26 October 2022

DA 115/2022 | 11-19 HOLDSWORTH AVE & 10-20 BERRY RD, ST LEONARDS SOUTH | RESUBMISSION TO DESIGN EXCELLENCE PANEL

Figure 1: Proposal's amended finishes strategy (Source: Silvester Fuller Architects)

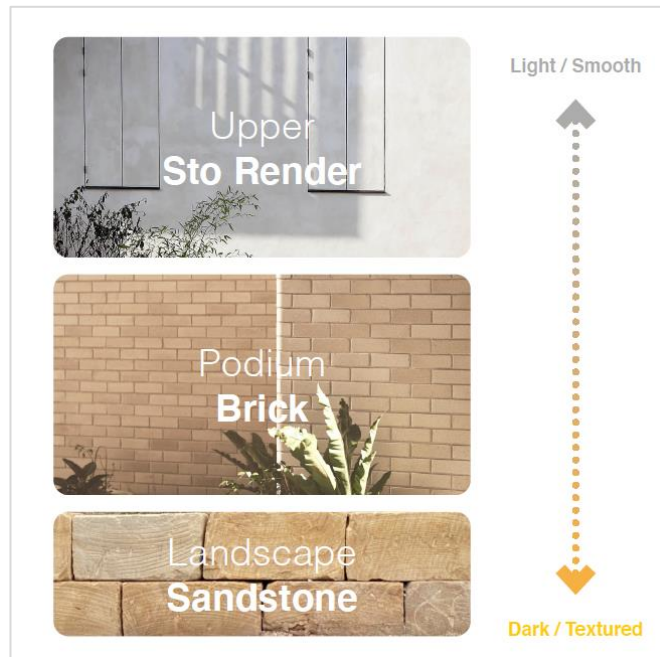
Elevations and materiality should be developed to reflect the existing context and neighbouring properties

The proposal has been amended such that its elevations and materiality will generally include sandstone throughout the ground level landscaped areas, masonry within the podium, as well as light coloured Sto render in the upper portions of the envelope.

The sandstone and masonry reflects the existing character, whilst the Sto render represents a contemporary finish which will be an inevitable character of the emerging precinct. The materials would also generally be darker at ground level, and lighter as height increases. This is for the purpose of integrating with the skyline and lessening visual bulk.

Figure 2: Amendments to location of childcare centre (Source: Silvester Fuller)

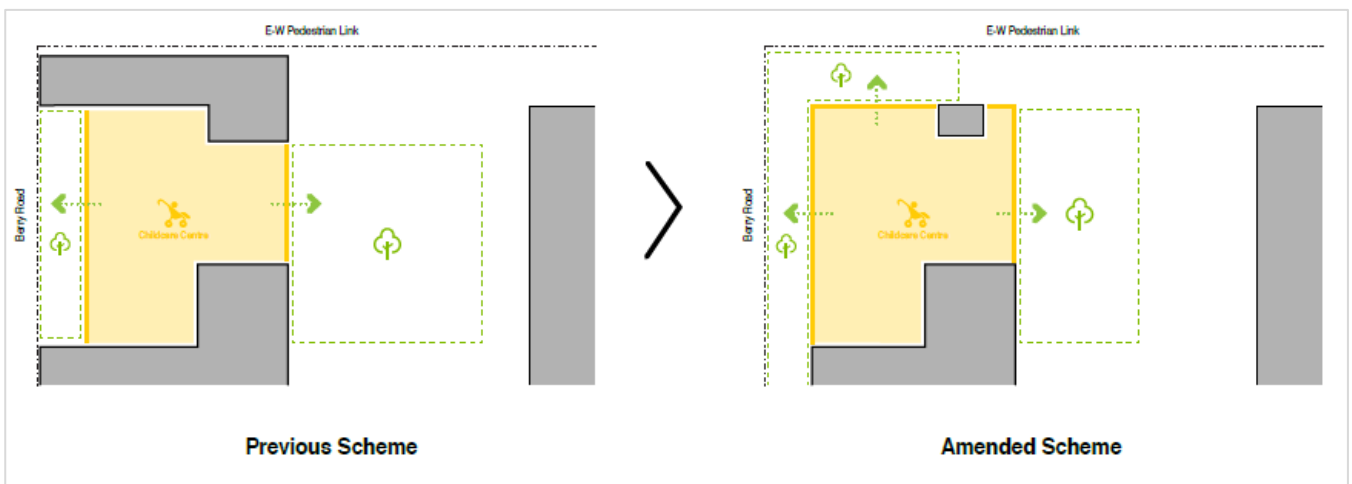
Reorientation of childcare centre, 'secret gardens' and community facility to north

The proposal has been amended such that it adopts this suggestion from the DRP. Specifically, the childcare centre and community centre are re-oriented, and some upper massing has been removed, such that it has a greater address to the Berry Rd and the east west pedestrian link.

Figure 3: Amendments to location of community centre (Source: Silvester Fuller)

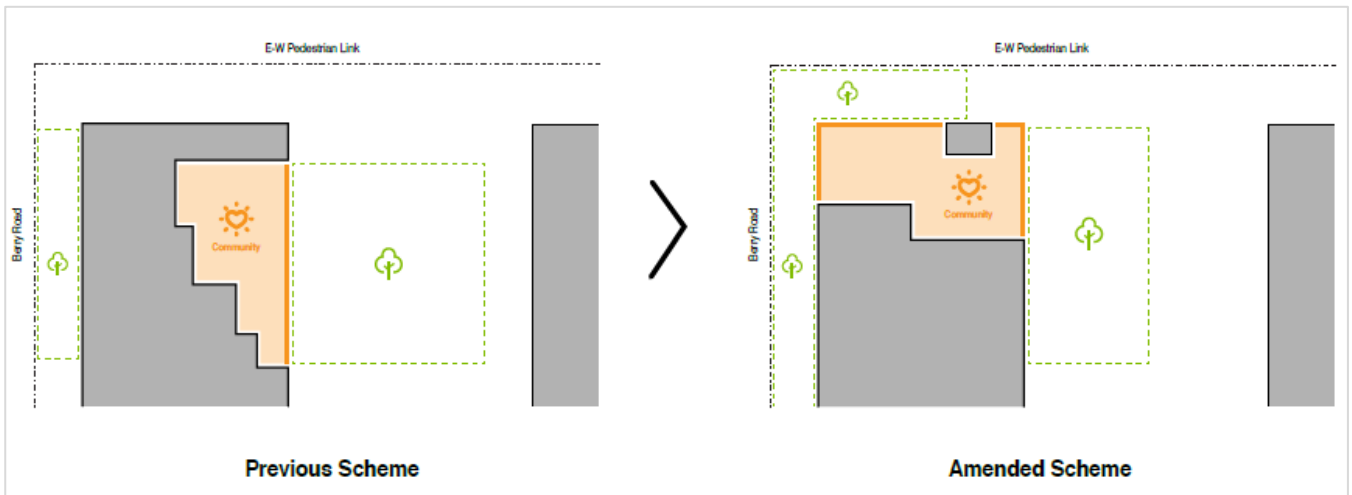
Reconsider size and location of childcare centre outdoor play area to improve resident's amenity

The reorientation of the childcare centre, as discussed earlier, has enabled the relocation of some of the required outdoor play area away from the central spine, to along the pedestrian link. The depth of the outdoor play area remaining within the central spine is subsequently reduced, thereby providing a larger buffer to residents within the Holdsworth building (refer to Figure 3 above).

Figure 6: Extract of overall landscaping and deep soil landscaping plan, with deep soil landscaping along southern boundary outlined red (Source: Silvester Fuller)

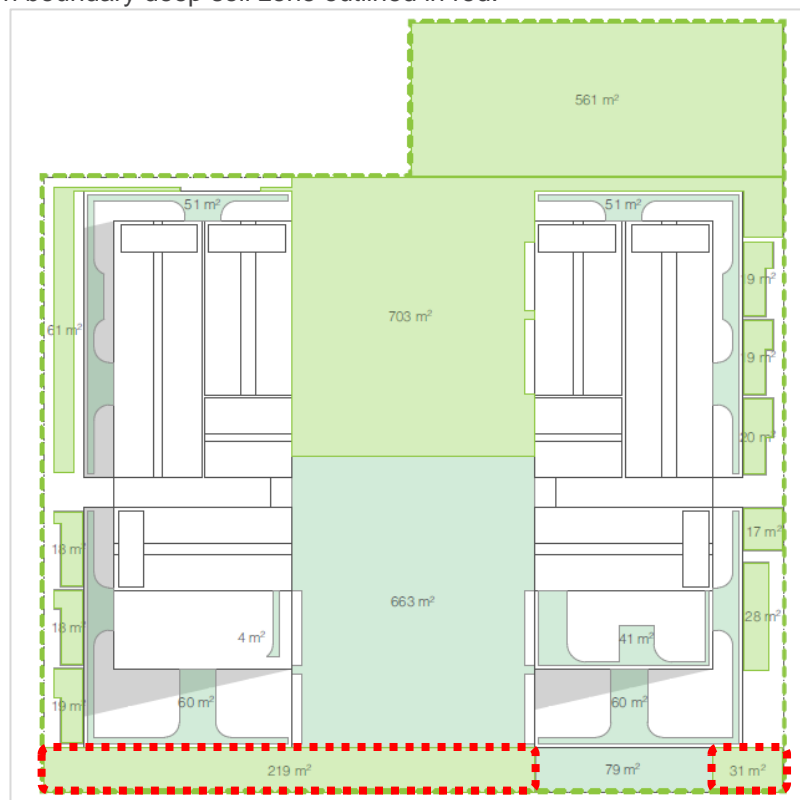
Substantiate deep soil and sun light availability along southern boundary

Clarification required in relation to location of deep soil zones

Page 69 of the Design Excellence Report prepared by Silvester Fuller substantiates the provision of all landscaping for the proposal, including deep soil landscaping. An extract of the plan is provided on the following page, with the southern boundary deep soil zone outlined in red.

The landscaping plan provided at page 69 of the Design Excellence Report clarifies the location of proposed landscaping, including deep soil zones. An extract of the plan is provided at Figure 6 above.

Figure 7: Extract of sun's eye view diagram with solar access to southern boundary landscaping show red (Source: Silvester Fuller)

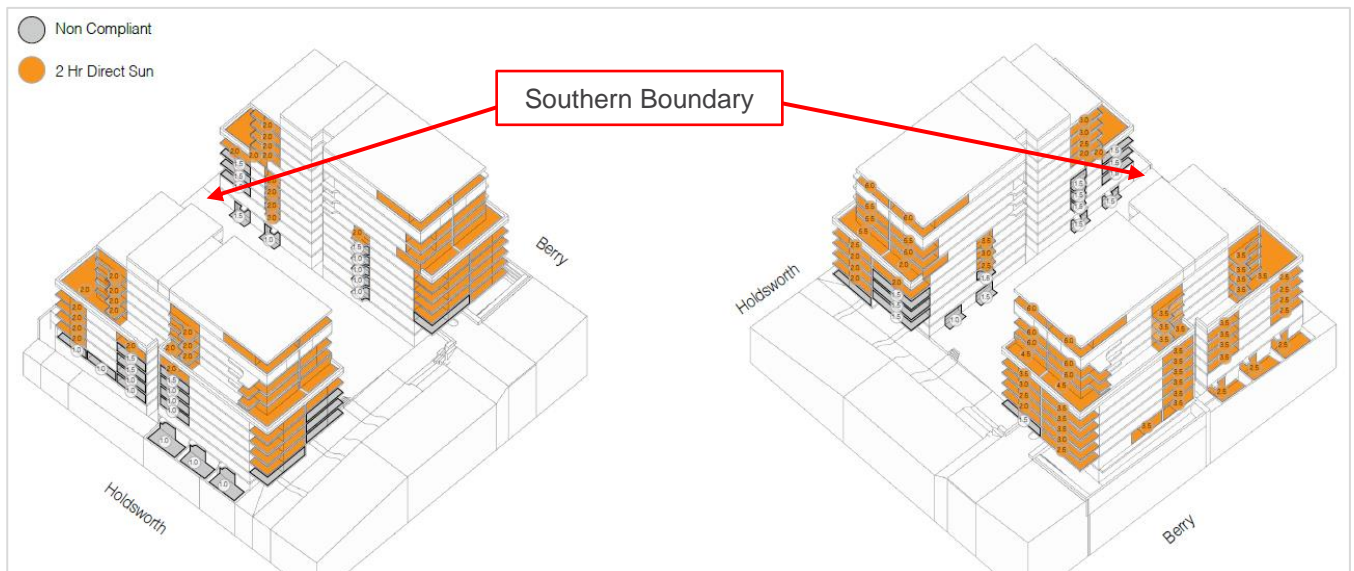
Graphically demonstrate 2 hours solar access to living spaces and POS of east and south facing dwellings

The view from the sun diagrams provided at page 61 of the Design Excellence Report prepared by Silvester Fuller demonstrate the extent of solar access to landscaping along the southern boundary. It should be noted that these plans are for the purpose of demonstrating solar access to the entire development. An extract of the plan is provided on the following page.

Sun's eye diagrams have been included in both the accompanying Design Excellence Report, as well as the DA's architectural plans, to address this matter. An example is provided at Figure 7.

Figure 11: Extract of east-west elevation with 2.5m height limit shown red (Source: Silvester Fuller)

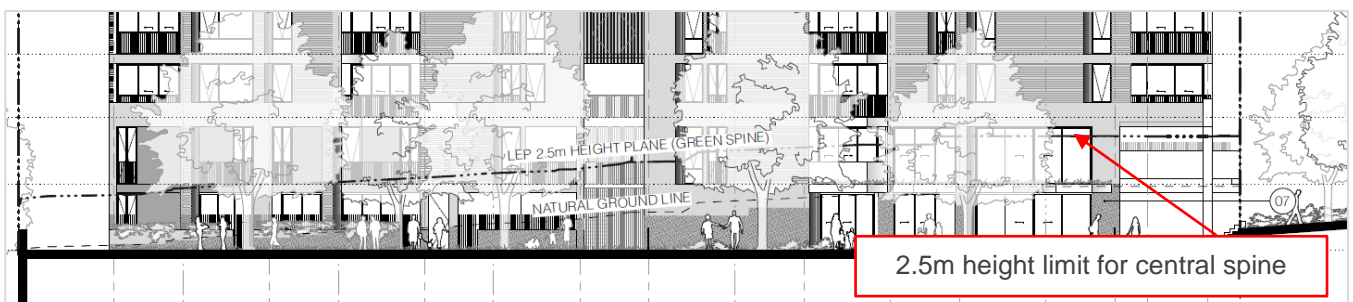
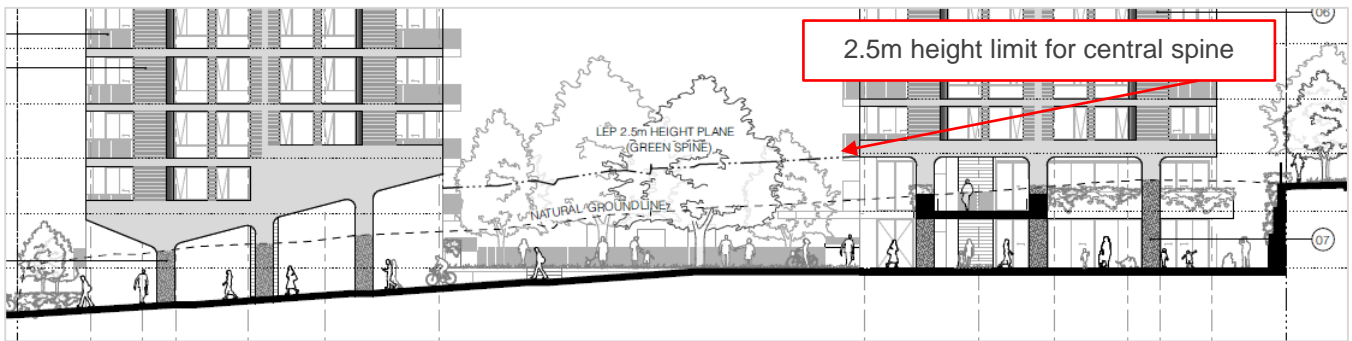
Height of structures within central spine

Following the initial DRP meeting, any structures within the central green spine have been revised such that they are below the 2.5m height standard. This is demonstrated in the architectural plans submitted with the DA. Relevant extracts from DA_A-210-004 and DA_A-210-003 are provided below.
